UNITED STATES PATENT AND TRADEMARK OFFICE

10/791,052

Office Action Summary	Application No. 10/791,052	Applicant(s) TSUNG-JUNG, KUO	
	Examiner Matthew G. Kayrish	Art Unit 2627

DETAILED ACTION

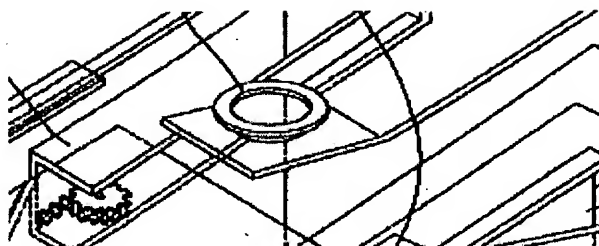
Regarding claim 20, Choi discloses:

A disk-anchoring device of an optical disk device, comprising:

A substrate (figure 3, item 216);

A clamper frame (figure 3, item 222) for holding a clamper (figure 3, item 222), pivoted (figure 3, pivots about item 234) on said substrate (figures 3 & 4) and having a first protrusion portion (figure 2, item 238);

A sliding element (figure 3, item 234), movably mounted on said substrate (column 3, lines 48-52) and having an inclined portion (figure 3, item 246) and a second protrusion (figure 2 below);

The disk-anchoring device as claimed in claim 20, wherein said clamping frame has a clamping flange (figure 1 below), and said clamping frame is mounted on said clamping flange (figure 1, item 220 is supported by the clamping flange).
